HISTORIC AND DESIGN REVIEW COMMISSION

HDRC CASE NO: 2018-327
ADDRESS: 4040 BROADWAY
LEGAL DESCRIPTION: NCB 3081 BLK 2 LOT 1 THRU 4 & 8 THRU 12
ZONING: C-2, C-1, RIO-1
CITY COUNCIL DIST.: 2
APPLICANT: Edna Geckler/RPA Property Manager. MSG Management
OWNER: 4040 Broadway, LLC
TYPE OF WORK: Signage
APPLICATION RECEIVED: June 29, 2018
60-DAY REVIEW: August 28, 2018

The applicant is requesting a Certificate of Appropriateness for approval to install one, internally illuminated sign on the north façade of the structure at 4040 Broadway. The proposed signage will be located along the parapet wall, opposite of an existing sign. The proposed signage will feature an overall height of 4' – 6" and an overall width of 20'. The proposed sign will read "Kindred Hospice".

NORTH ELEVATION: (THORMAN PLACE)
WALL SIGN

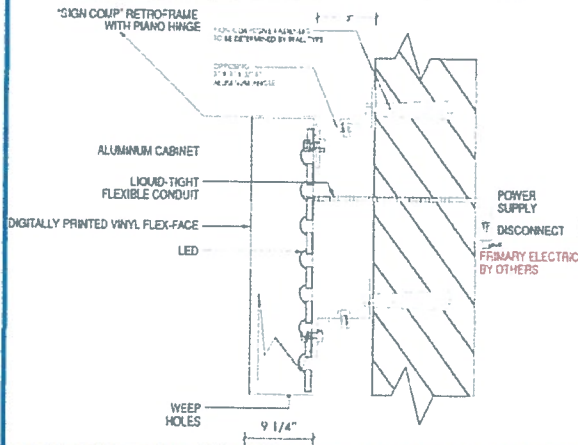
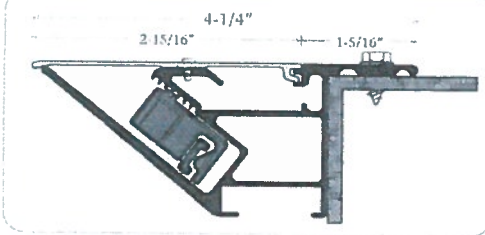
and an overall width of 20'. The proposed sign will read "Kindred Hospice". Per the UDC Section 35-678(e), signage should not exceed more than fifty (50) square feet per application. While the proposed ninety (90) square feet is larger than that recommended by the commission, staff finds that given its height above street level, the proposed square footage is appropriate.

- c. **SIGNAGE** – The applicant has proposed for the signage cabinet to feature materials that include aluminum with a vinyl flex face. Illumination will be through internally located LED's. The UDC Section 35-678(c)(1) notes that sign materials shall be compatible with the materials of the building's façade. Staff finds that the proposed vinyl flex face is inconsistent with the UDC. Staff finds that a sign constructed of aluminum with reverse channel letters or a halo lit sign would be more appropriate than the proposed plastic face.

Staff does not recommend approval based on finding c. Staff recommends a sign that does not feature a vinyl face be installed. Reverse channel letters or halo lighting would be appropriate.
